Drinking Water Audit Report

County:	Mayo	Date of Audit:	23 February 2016
Plant(s) visited:	Swinford WTP	Date of issue of Audit Report:	7 March 2016
		File Reference:	DW2014/14
		Auditors:	Ms Derval Devaney Ms Michelle Roche
Audit Criteria:	<ul style="list-style-type: none"> • The <i>European Union (Drinking Water) Regulations 2014 (S.I. 122 of 2014)</i>. • <i>The EPA Handbook on the Implementation of the Regulations for Water Services Authorities for Public Water Supplies (ISBN: 978-1-84095-349-7)</i> • The recommendations specified in the <i>EPA Drinking Water Report</i>. • EPA Drinking Water Advice Notes No.s 1 to 15. • The recommendations in previous audit reports.

Photo 1 Rust on 1st contact tank

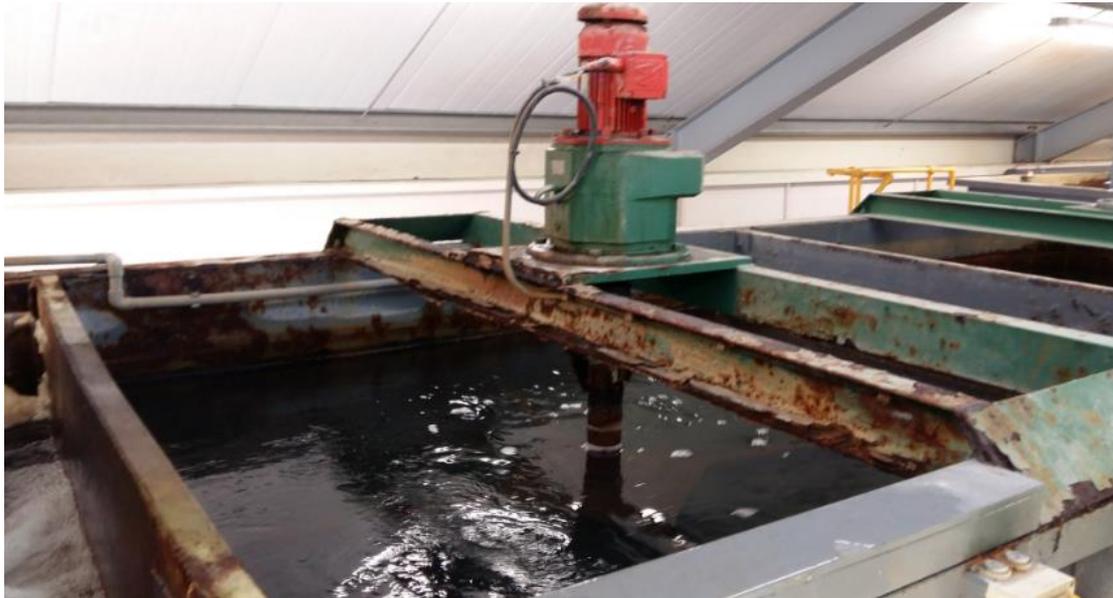
- (d) ensure the contact tank is inspected and maintained on a regular basis so that it is free from rust and structurally sound.
